**Report to the Future Melbourne (Planning) Committee**

**Draft Development Plan: TP-2019-246  
156-232 Kensington Road, West Melbourne****18 August 2020****Presenter:** Evan Counsel, Director Planning and Building**Purpose and background**

PERRI PROJECTS  
**WEST MELBOURNE WATERFRONT**  
DEVELOPMENT PLAN  
AUGUST 2020

Figure 38.

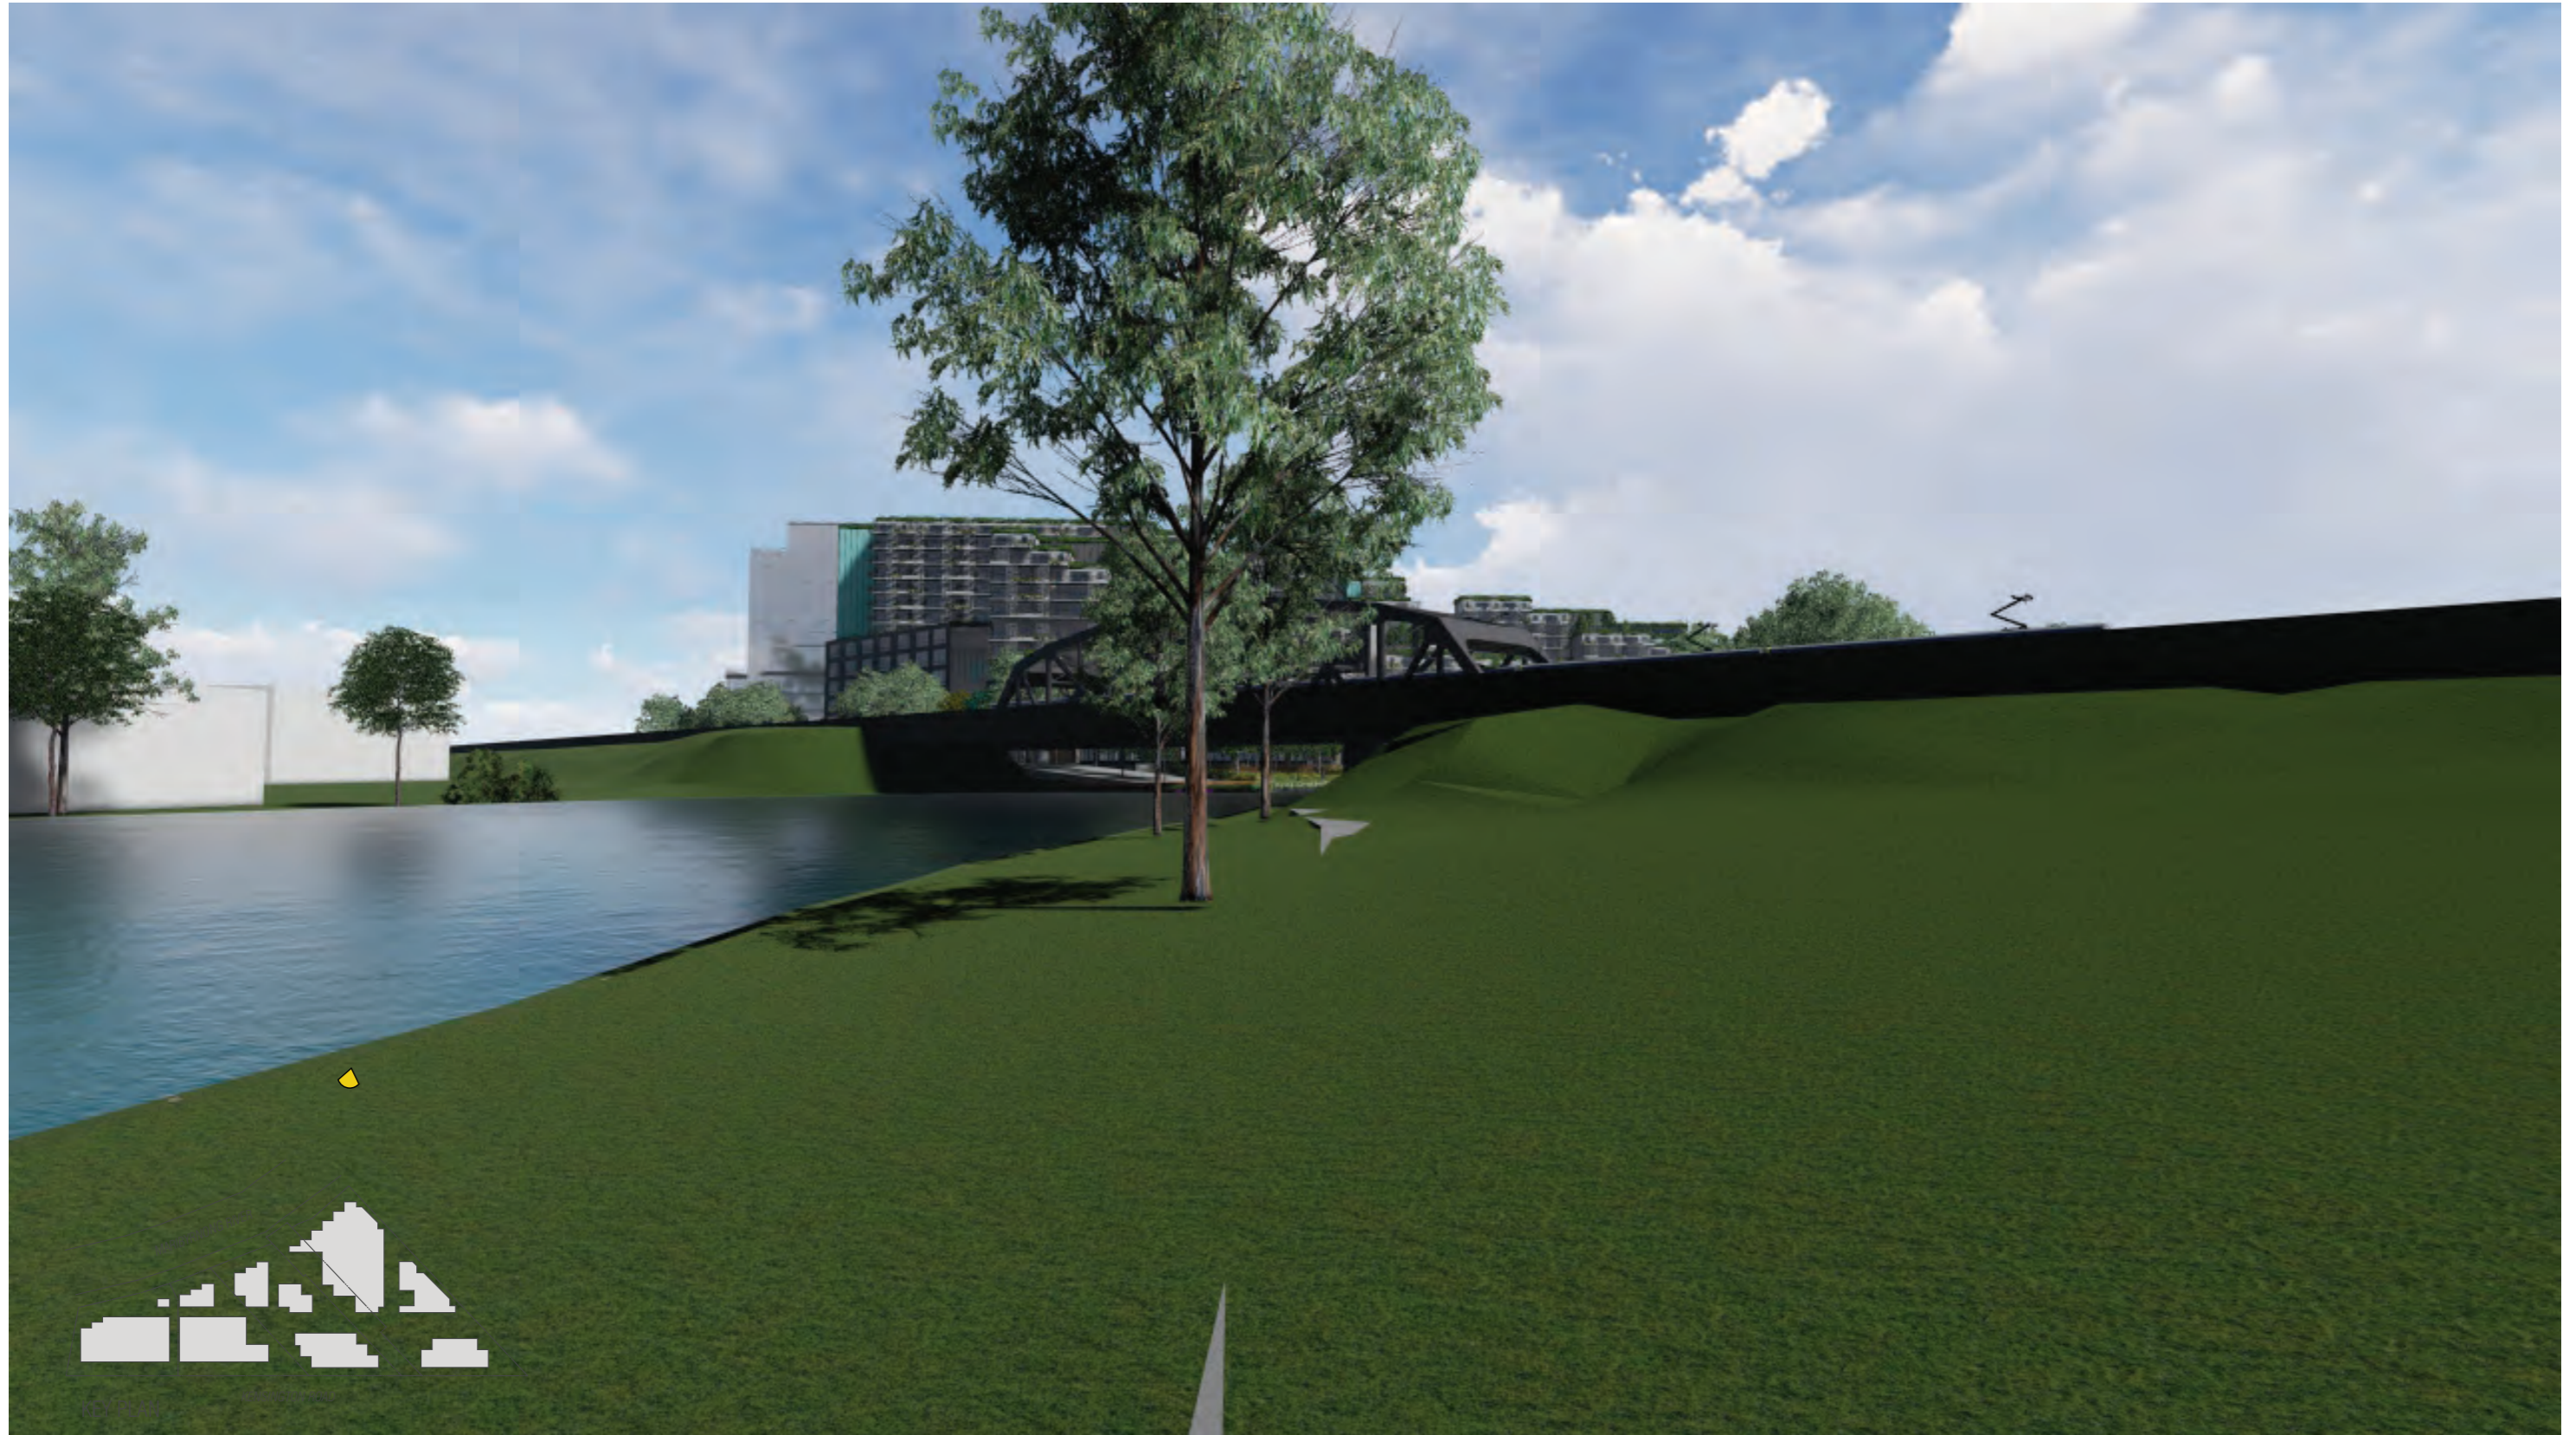
<p><b>Assessment</b></p>	<p>Provided:</p> <p>View from Newell's paddock (p. 66 of 69 of Development Plan (F+P &amp; FK)).</p> <p><small>VIEW FROM NEWELLS PADDOCK</small></p>  <p><small>Figure 38. *INDICATIVE ONLY</small></p> <p>View from Buddhist Temple (Heavenly Queen Temple) (p. 62 of 64 of Development Plan (F+P &amp; FK)).</p> <p><small>VIEW FROM BUDDHIST TEMPLE</small></p>  <p><small>Figure 39. *INDICATIVE ONLY</small></p>	<p>No <input type="checkbox"/></p> <p>Yes, subject to updates <input type="checkbox"/></p>
<p><b>Requirement 8</b></p>	<p>If it is proposed to develop the land included in this overlay in stages, the staging plan must identify, to the satisfaction of the Responsible Authority:</p> <ul style="list-style-type: none"> <li>▪ The proposed sequencing of development, the indicative timing of the provision of infrastructure and services and overall integration with other development stages.</li> <li>▪ Vehicular access points, road infrastructure works and traffic management for each stage of the development.</li> </ul>	<p>Yes <input checked="" type="checkbox"/></p> <p>No <input type="checkbox"/></p> <p>Yes, subject to updates <input type="checkbox"/></p>

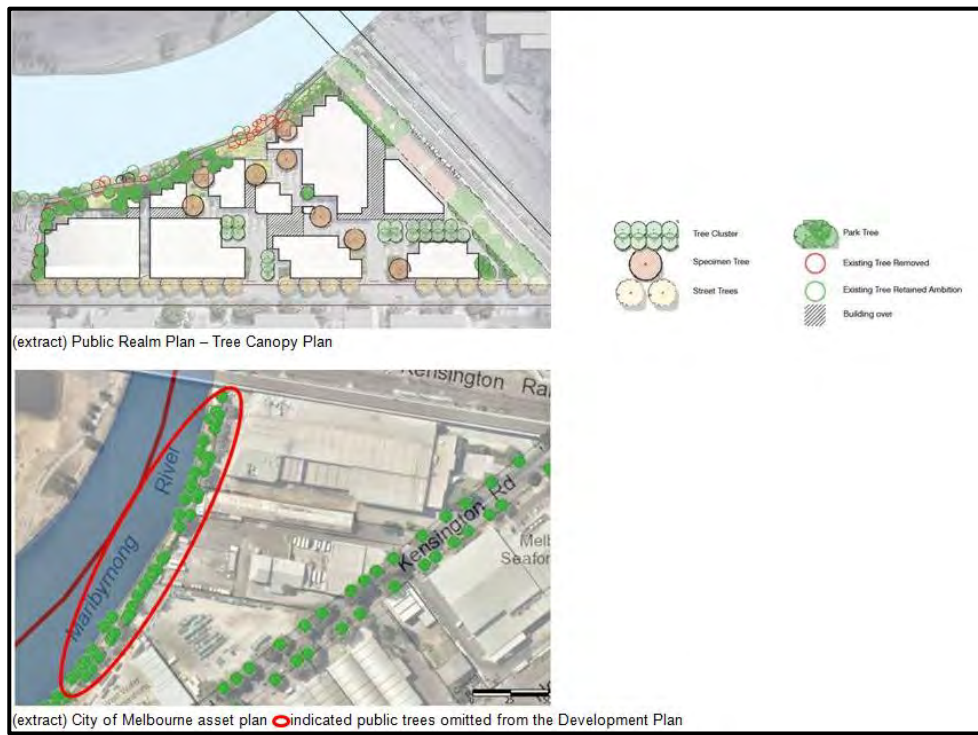
On 6 May 2019, Council’s Urban Forestry team provided the following advice on Application TP-2019-246:

*Having reviewed the Development Plan I note that the Public Realm – Tree Canopy Plan (pg 23) has not identified public trees growing along the northern boundary.*

**9.4 DPO13 Indicative Framework Plan (Figure 1)**

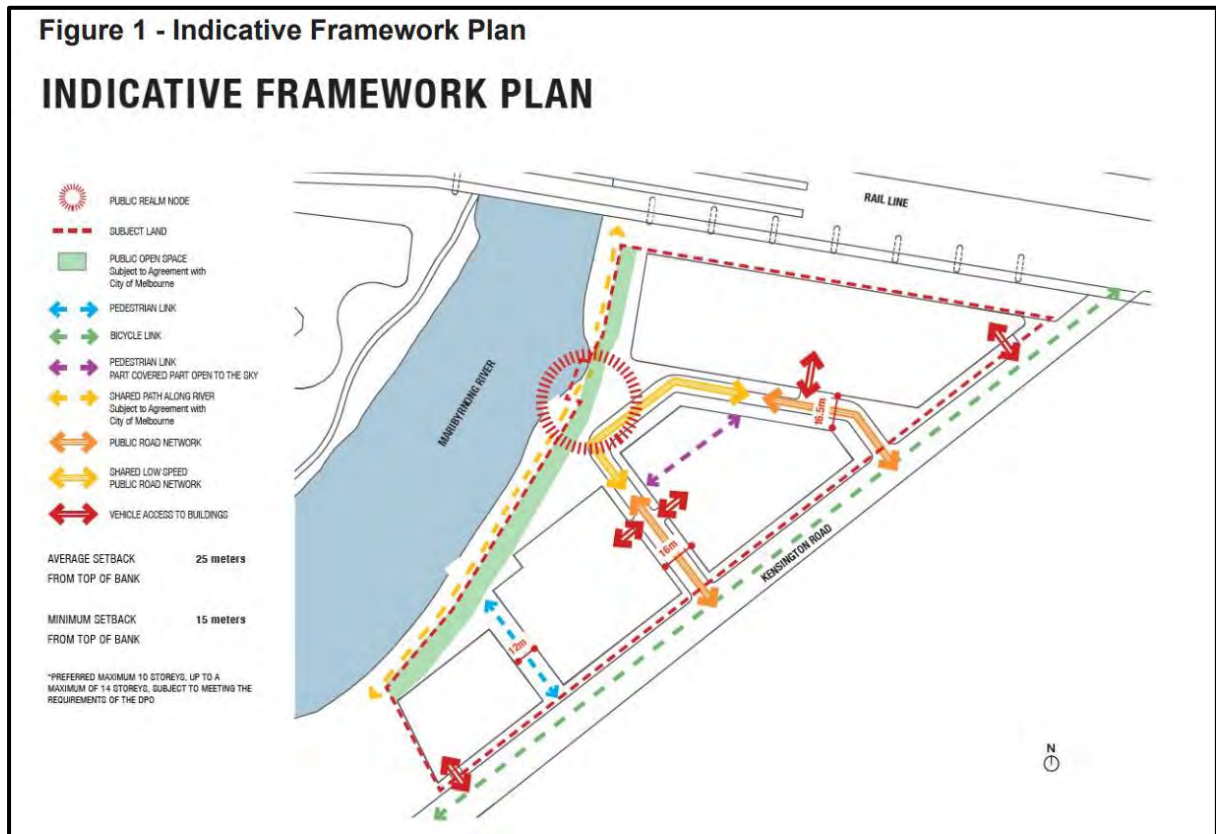
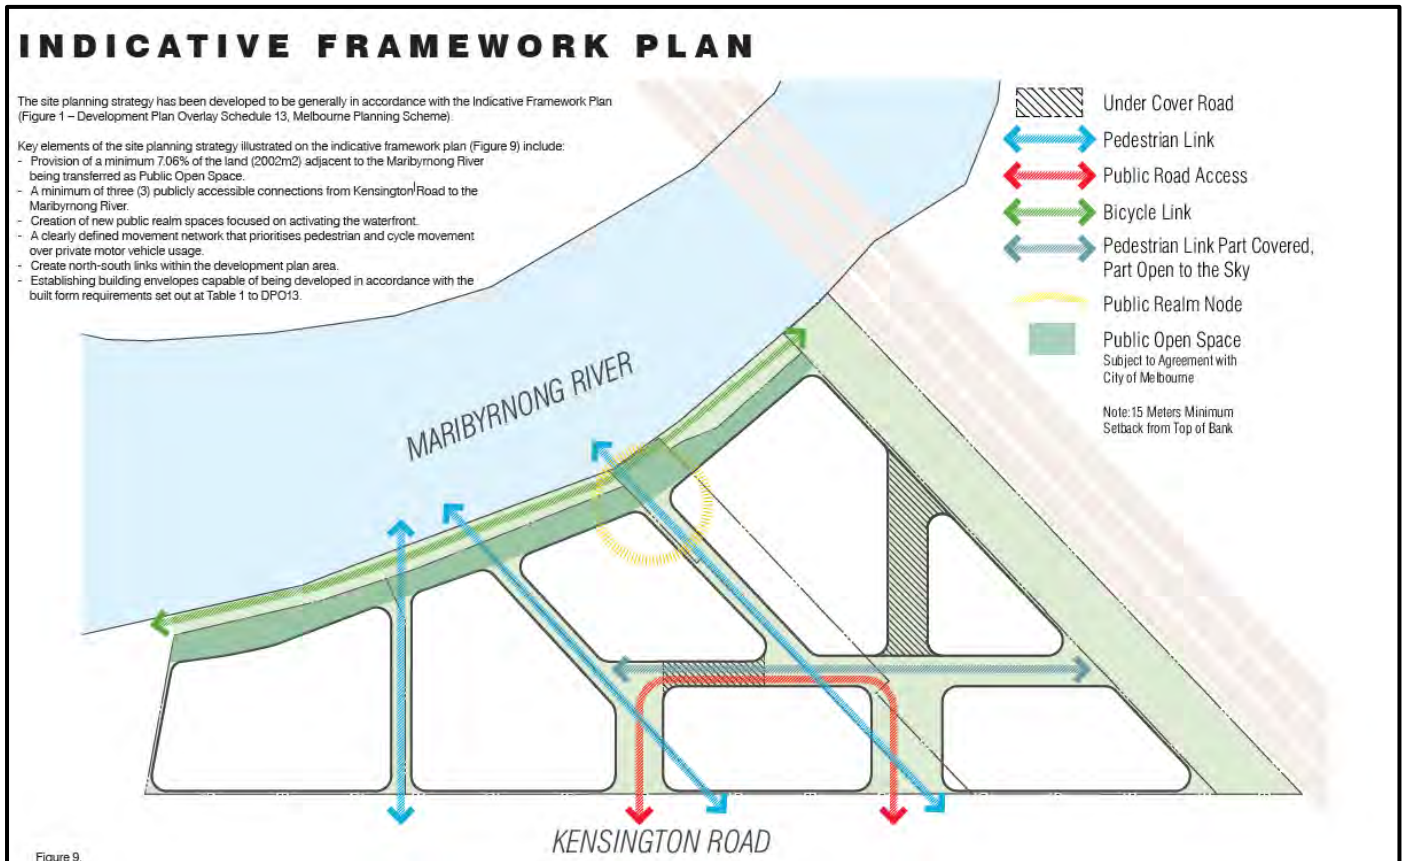
Excerpts from DPO13 and the Development Plan (F+K & FP) have been provided below, demonstrating the degree to which the proposed development plan under Application TP-2019-246 accords with the Indicative Framework Plan in Figure 1 of DPO13.

The table below includes an assessment of the proposed Framework Plan in the Development Plan (F+K & FP) against Figure 1 – Indicative Framework Plan of Schedule 13 to the Development Plan Overlay.

Table: Schedule 13 to Development Plan – Indicative Framework Plan	
Figure	Generally in accordance? (Green = Yes) (Red = No)
<p><b>Figure 1 – Indicative Framework Plan</b></p> <p><b>Assessment:</b></p> <p>The master plan envelopes detailed in indicative framework plan provided in the Development Plan (F+K &amp; FP) (p.17 of 69) of the proposed development plan generally conform to the Indicative Framework Plan identified in Figure 1 of DPO13.</p> <p>It is noted that the maximum number of storeys for the northernmost building envelopes, oriented toward the railway interface, is 14 storeys, which exceeds the 10 storey preferred height requirement and meets the mandatory height requirement.</p> <p>As it stands, the proposed development plan is considered to be generally in accordance with the Indicative Framework Plan of DPO13.</p>	<p>Yes <input checked="" type="checkbox"/></p> <p>No <input type="checkbox"/></p> <p>Yes, subject to updates <input type="checkbox"/></p>
